# HISTORIC AND DESIGN REVIEW COMMISSION

January 17, 2024

**HDRC CASE NO:** 2024-009  
**ADDRESS:** 115 WICKES  
**LEGAL DESCRIPTION:** NCB 937 BLK 2 LOT 18  
**ZONING:** RM-4, H  
**CITY COUNCIL DIST.:** 1  
**DISTRICT:** King William Historic District  
**APPLICANT:** Jim Bailey/BAILEY JAMES H R  
**OWNER:** Robert & Sarida Bradley/BRADLEY ROBERT E III  
**TYPE OF WORK:** Front porch replacement, column replacement, installation of porch screening, installation of foundation skirting  
**APPLICATION RECEIVED:** January 05, 2024  
**60-DAY REVIEW:** February 26, 2024  
**CASE MANAGER:** Edward Hall

# ELEVATIONS- NEW

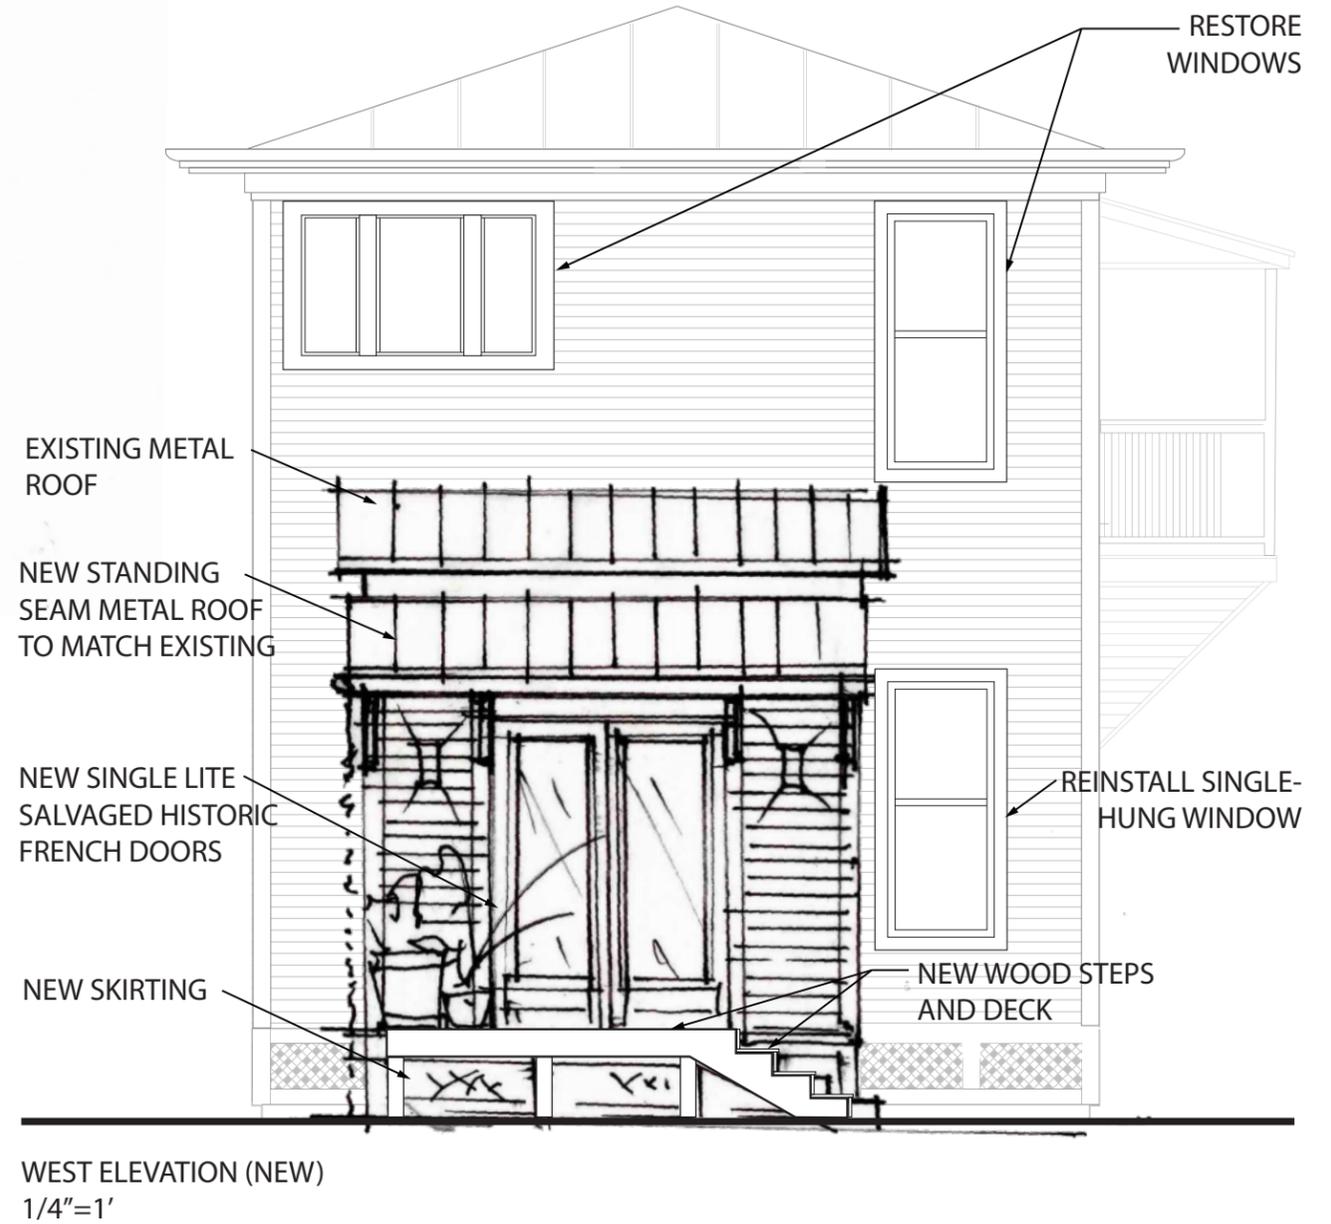
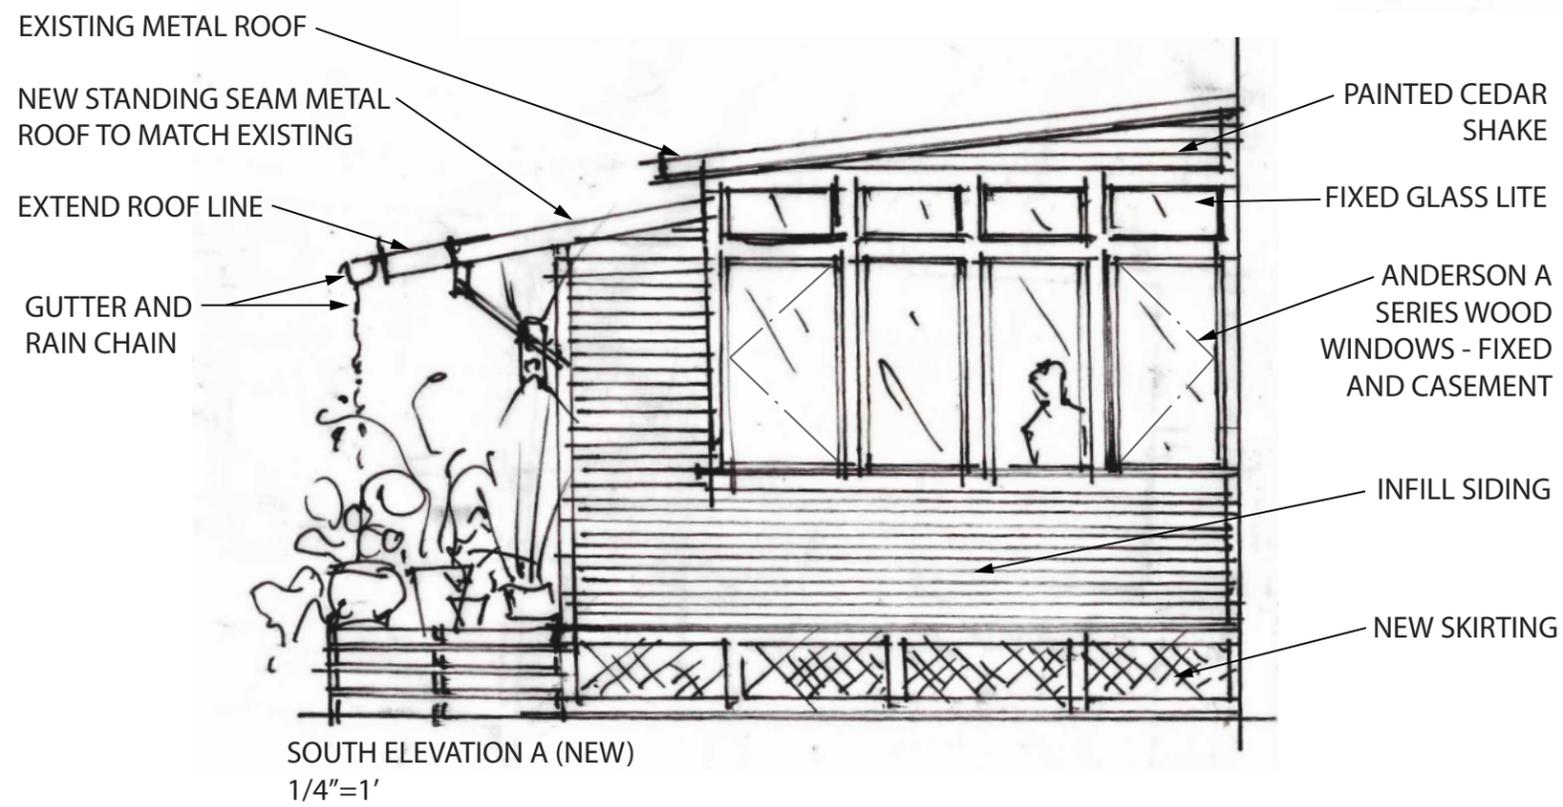
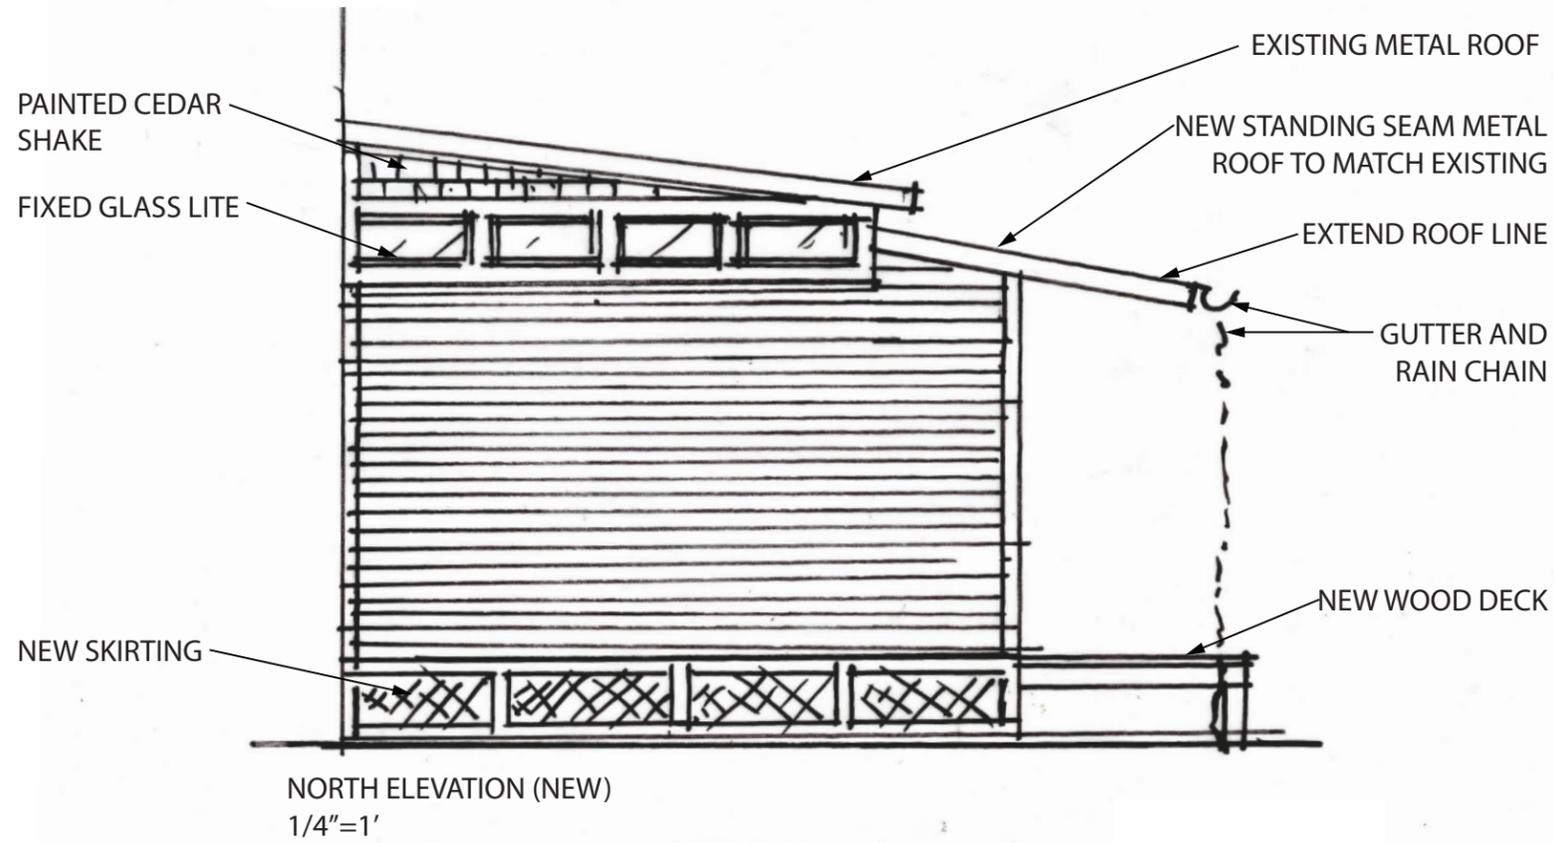
- c. PORCH REPLACEMENT – The applicant has proposed to replace the existing, non-original concrete porch with a new wood framed porch. The Guidelines for Exterior Maintenance and Alterations 7.B.iii. notes that porches should be replaced, in-kind. Whenever in-kind replacement is not feasible, the design should be compatible in scale, massing and detail while materials should match in color, texture, dimensions and finish. Staff finds the replacement of the non-original, concrete porch with a wood framed porch to be architecturally appropriate for the historic structure and consistent with the Guidelines. Staff finds that 1x3 tongue and groove porch decking should be installed perpendicular to the front façade, as found on historic wood porches.

- d. PORCH COLUMN REPLACEMENT – The existing porch columns feature non-original brick bases and wood column shafts with capital trim. The applicant has proposed to replace the existing columns with new box columns to match the profile of the existing (10 inches, square). The applicant has proposed to install a fourth column. The Guidelines for Exterior Maintenance and Alterations 7.B.iv. notes that replacement elements should be simple as to not distract from the historic character of the building and to not create a false historic appearance. Staff finds the proposed column replacement to be appropriate and consistent with the Guidelines. Staff finds that the proposed columns should feature trim to match the original wood columns found on site.

1. Staff recommends approval of item #1, porch replacement, based on findings a and c with the following stipulation:
  - i. That 1x3 tongue and groove porch decking be installed perpendicular to the front façade, as found on historic wood porches.
2. Staff recommends approval of item #2, the replacement of the existing porch columns with new columns and the installation of a four porch column based on findings a and d with the following stipulation:
  - i. That the proposed columns feature a profile (width and depth) and trim to match the original wood columns found on site.
3. Staff recommends approval of item #3, the installation of aluminum porch screening based on finding e, as submitted.
4. Staff recommends approval of item #4, the installation of wood lattice foundation skirting based on finding f, as submitted.

# SCREEN DETAILS

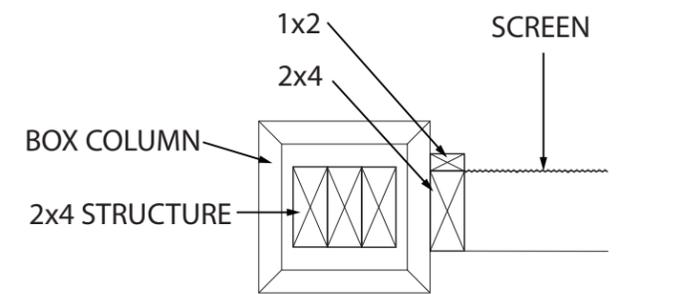
- e. PORCH SCREENING – The applicant has proposed to install aluminum screening to screen the front porch in its entirety. The Guidelines for Exterior Maintenance and Alterations 7.B.i. notes that applicant should refrain from enclosing front porches. The Guidelines additionally note that approved screen panels should be simple in design as to not change the character of the structure or historic fabric. The applicant has noted aluminum screening that will result in a high level of transparency. The screening panels will be installed behind the face of the columns and will be framed in wood. Staff finds this request to be appropriate and consistent with the Guidelines.

# SKIRT DETAILS

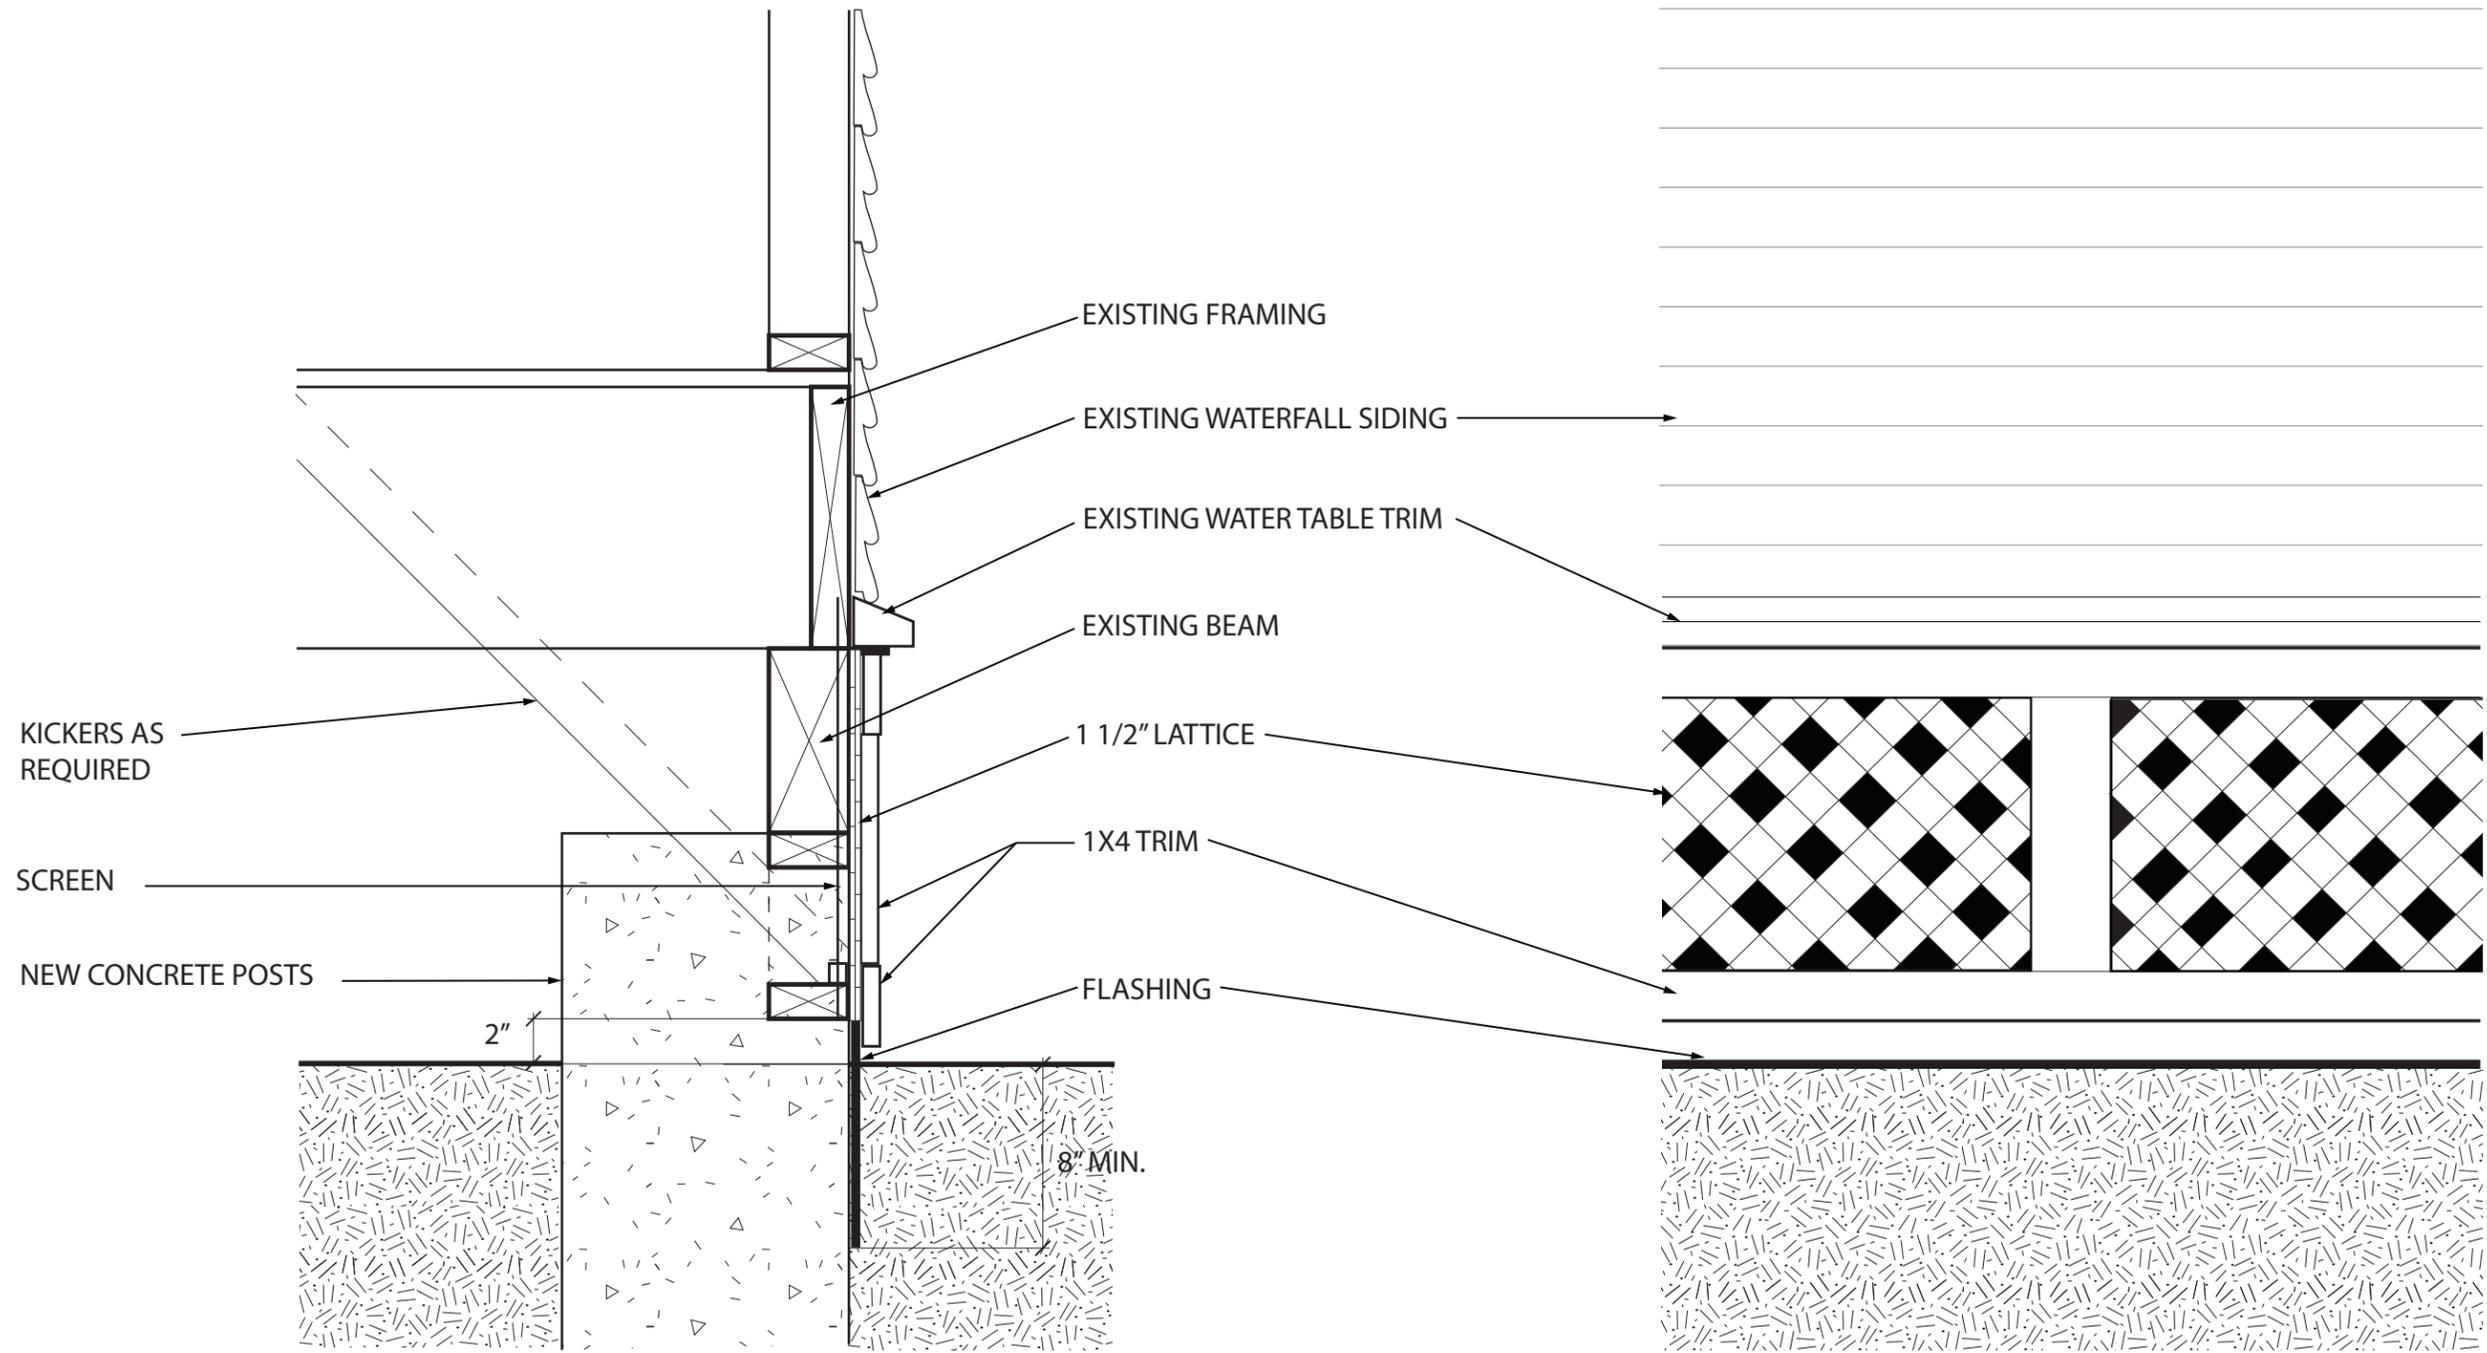
- f. FOUNDATION SKIRTING – The applicant has proposed to install wood lattice foundation skirting on each façade. The Guidelines for Exterior Maintenance and Alterations 8.B.i. notes that replacement skirting should consist of durable, proven materials, and should either match the existing siding or be applied to have minimal

visual impact. Staff finds the proposed skirting profile to be appropriate for the architectural style of the historic structure and consistent with the Guidelines.
